Re: Eldorado National - California
Defect and Non-Compliance Report

08V-073
(12 pages)

ISL / ISC CM850 FUEL LINE BRACKET

C0610 j 11-JAN-2008

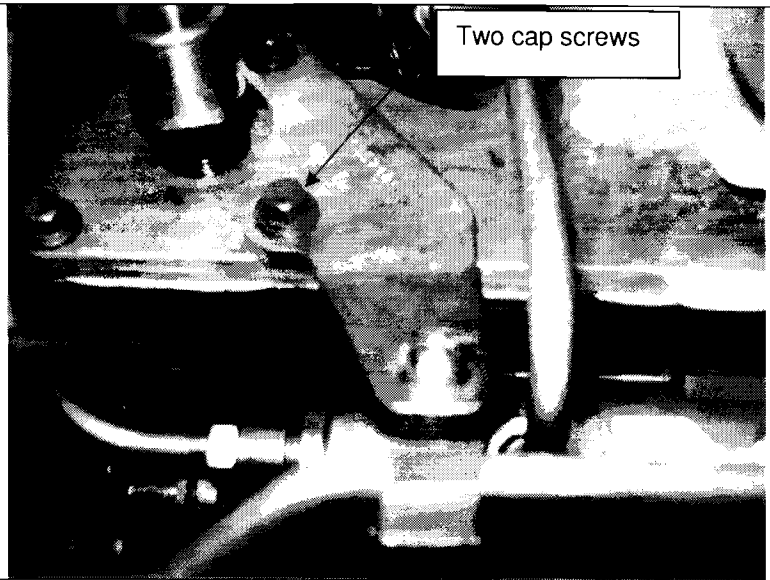
Remove the two (2) cap screws on the top of the intake manifold cover plate.

Install the bracket over the two (2) cap screw holes.

Initially, install the two capscrews finger tight.

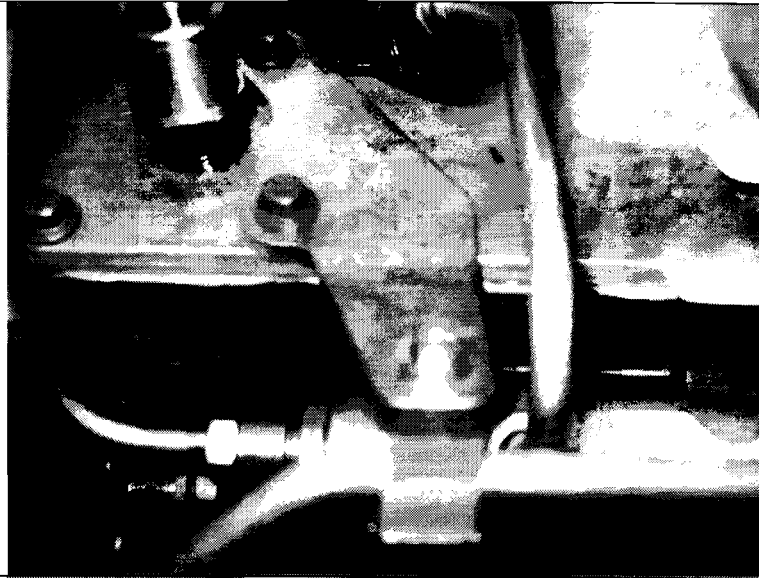
Install the fuel line finger tight between the bracket isolators.

Then, install the bracket isolator capscrew finger tight.

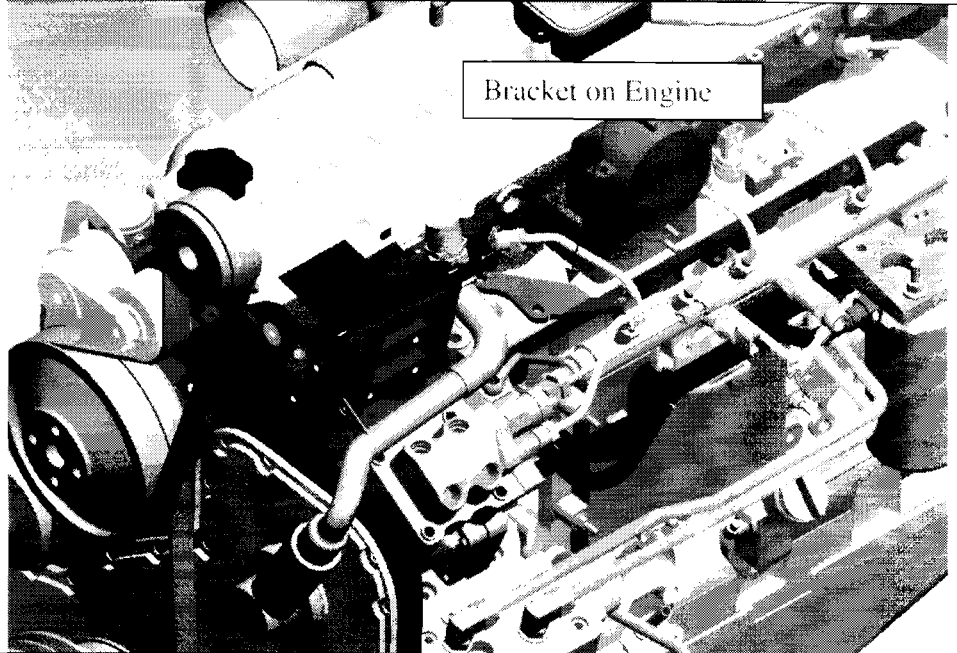
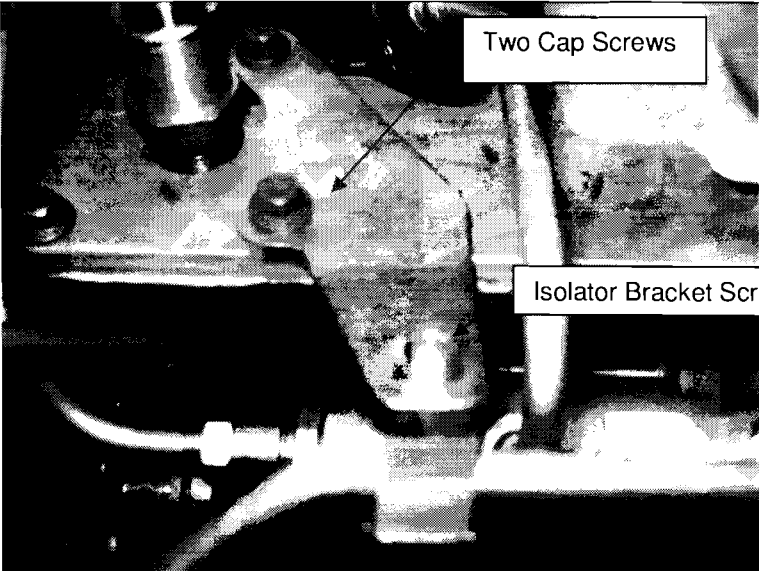
Torque the fuel line.

Refer to Injector Supply Lines (High Pressure) Procedure 006-051 in the Troubleshooting and Repair Manual ISC, ISCe, QSC8.3, ISL and QSL9 Engines Manual Bulleting 4021418.

Tighten the bracket screws to the intake manifold cover plate. Torque Value: 24Nm [18 ft-lb]	
Tighten the isolator bracket screw. Torque Value: 9Nm [7 ft-lb]	
Start the engine and check for leaks.
